# ENCORE APARTMENTS

DPD # 3020094  
2ND DESIGN RECOMMENDATION  
20 DECEMBER 2016

**PROJECT ADDRESS:**  
3010 1st Ave.

Balconies Distribution

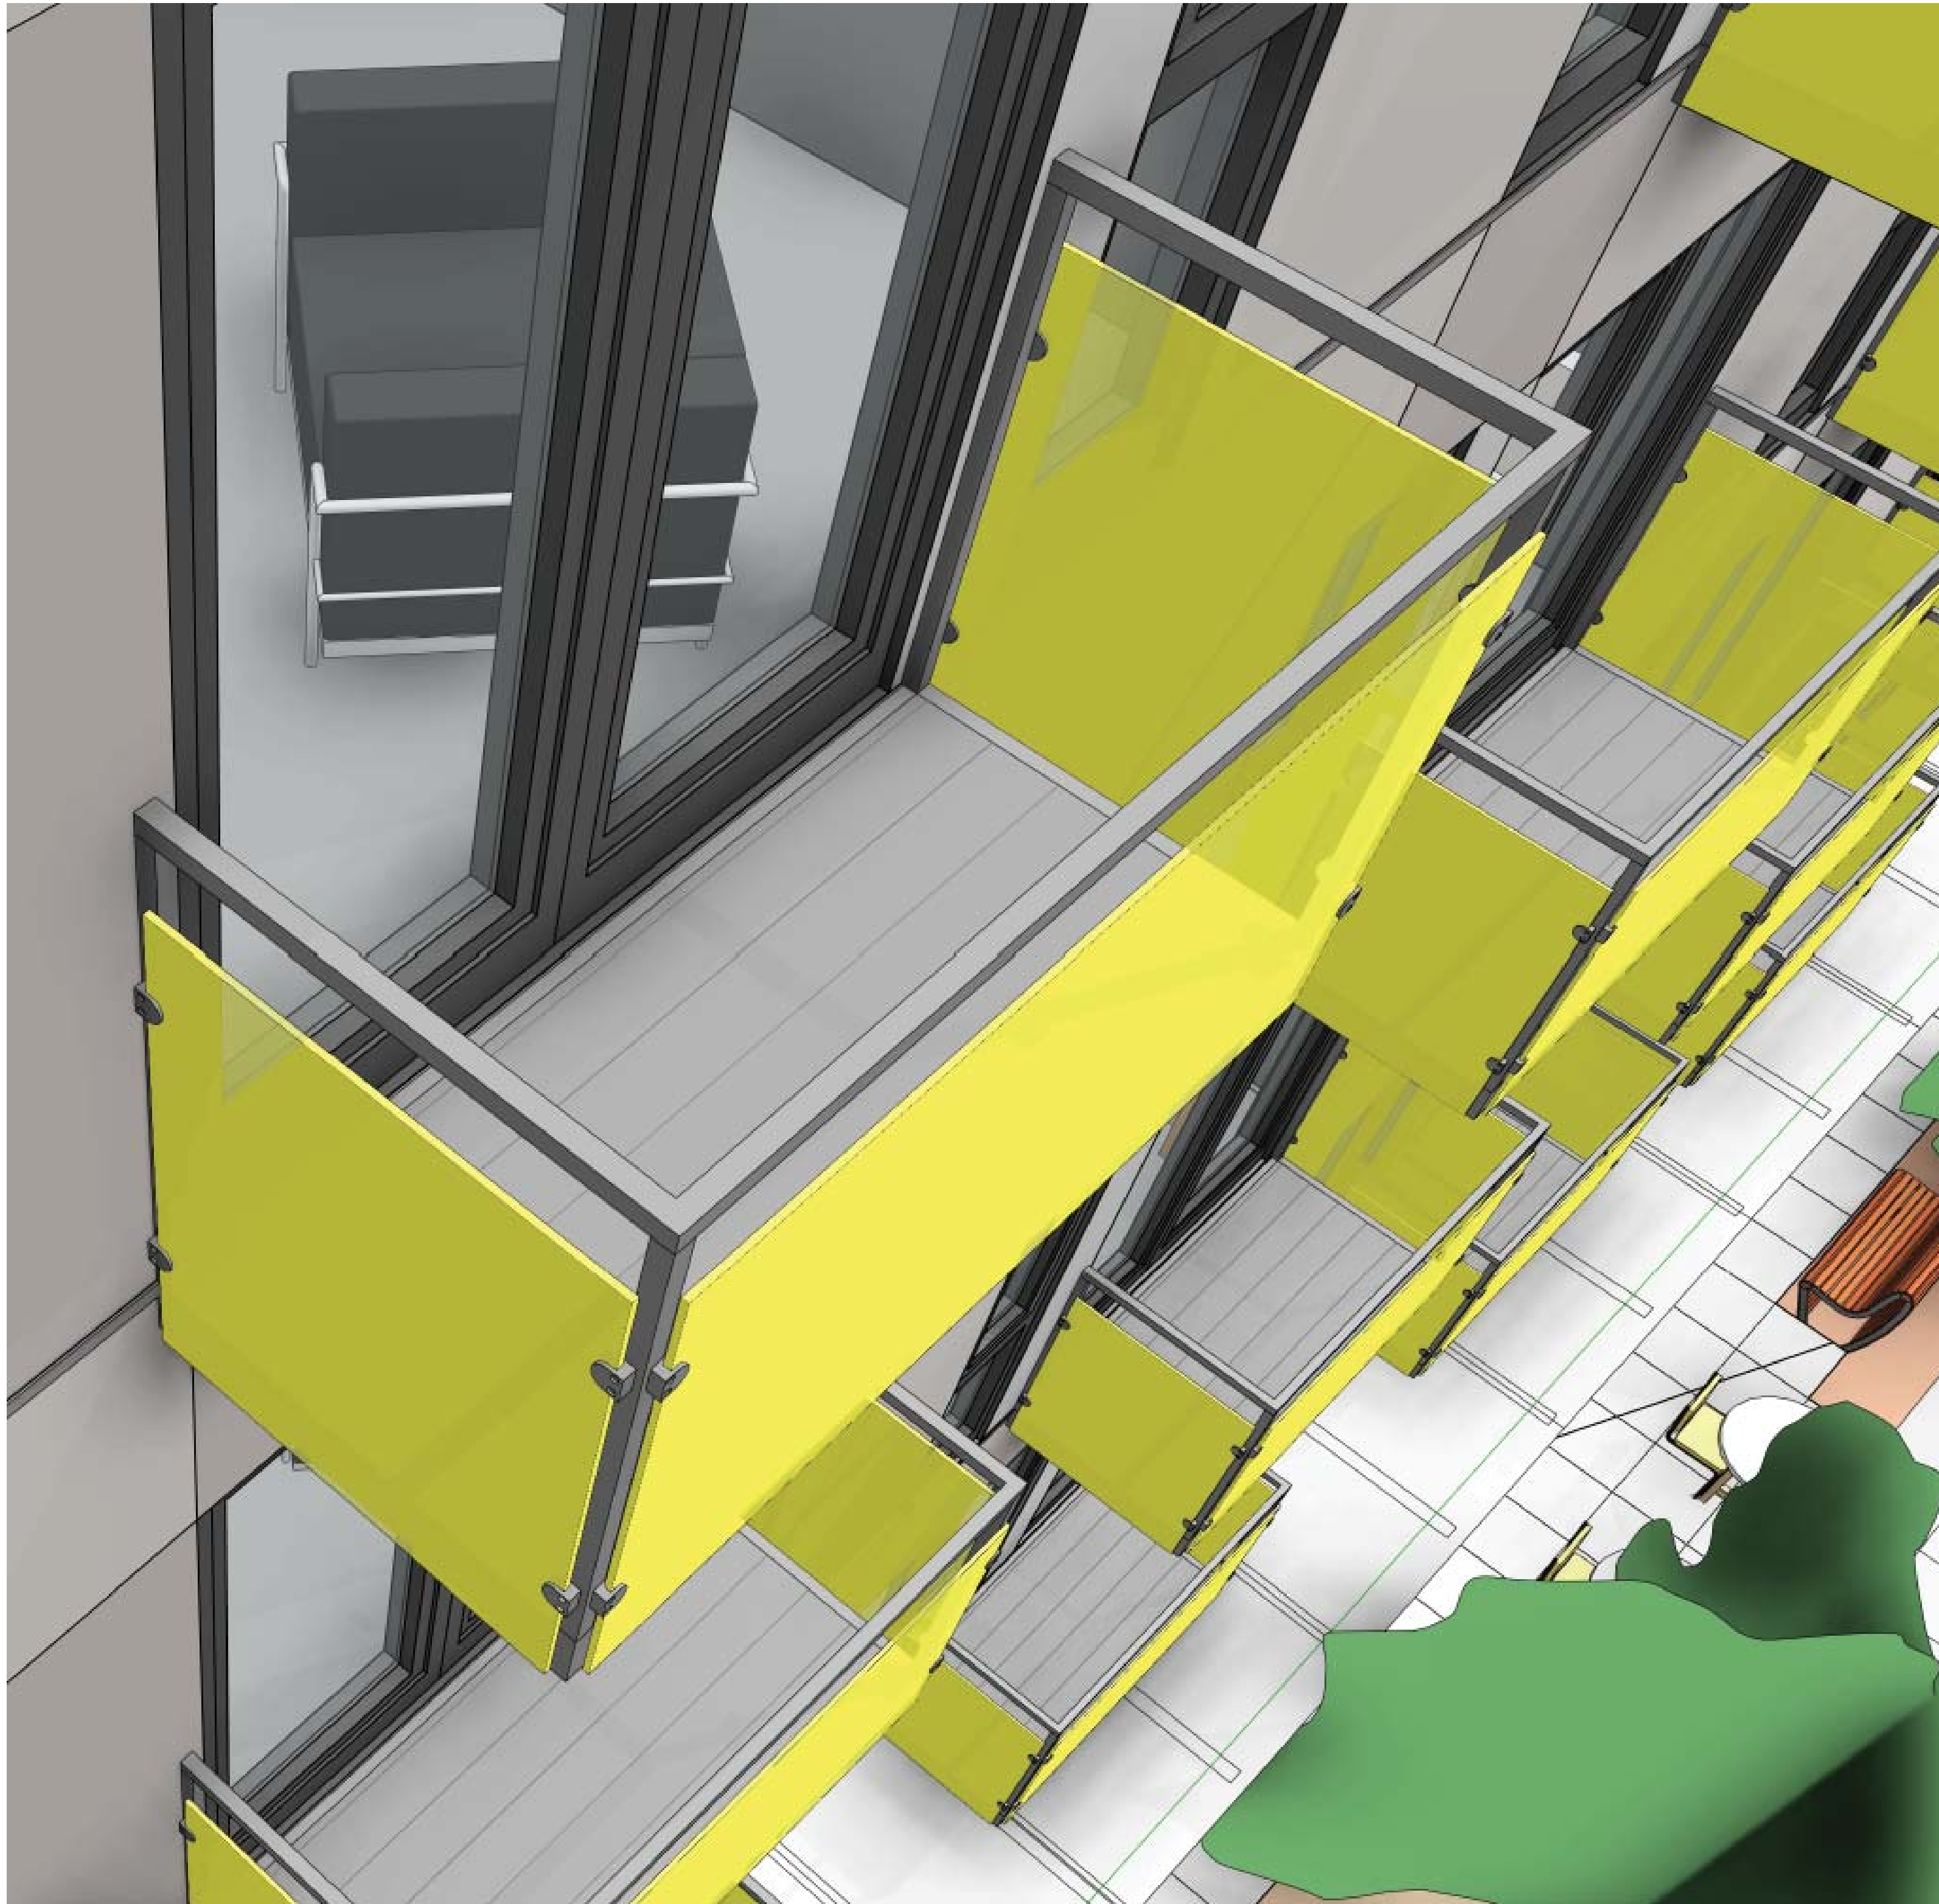
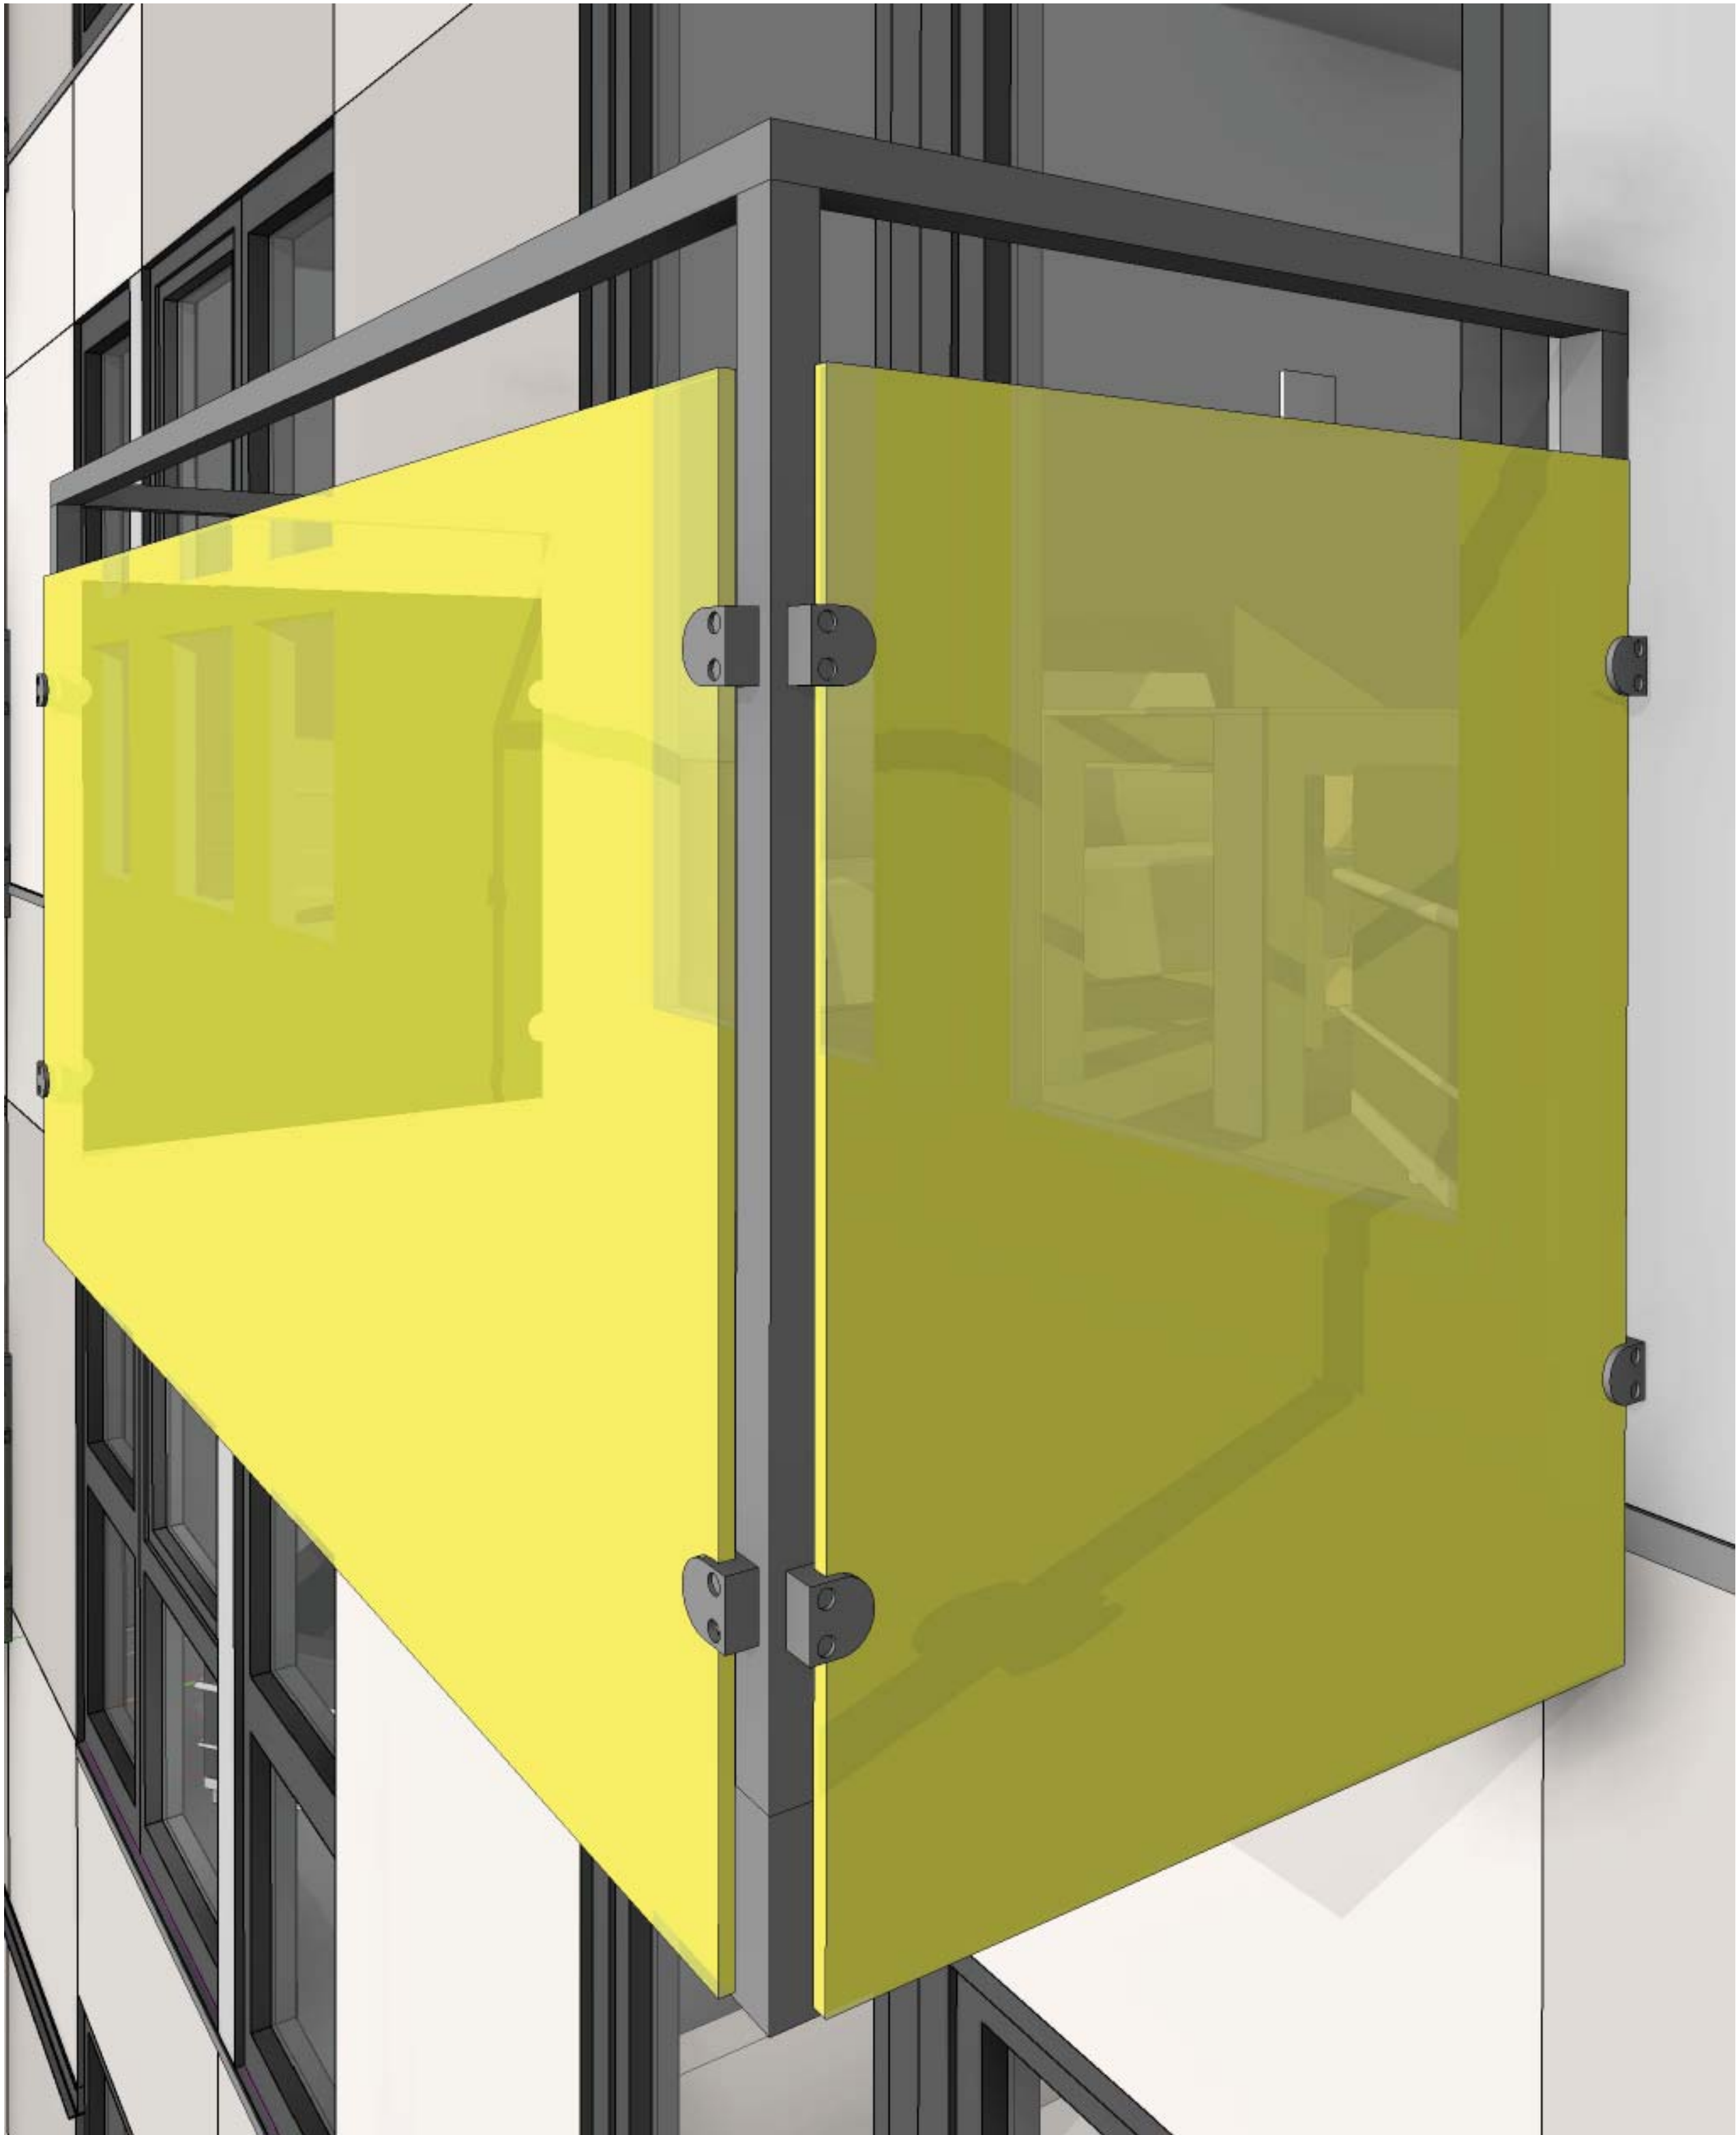
*“...The Board was concerned with the lack of balconies shown in the preferred massing option and recommended the applicant study using articulated rather the juliet balconies to break up the building facade...a taut skin facade expression, In order to create a smooth plane, the board recommended accentuating the verticals or minimizing the joints entirely (B4.2, B4.3)”*

Decks are often not provided at units this small because of construction cost and it’s effect on rents. The design of this balcony would be expensive. The tenant could open the sliding glass door to ventilate the unit and get an outside experience. It is 3’-0” deep by 6’-6” wide. Greater then 3’-0” deep would require it to be accessible. It would seem to run counter to the Board’s desire for a more “taut skin” expression.
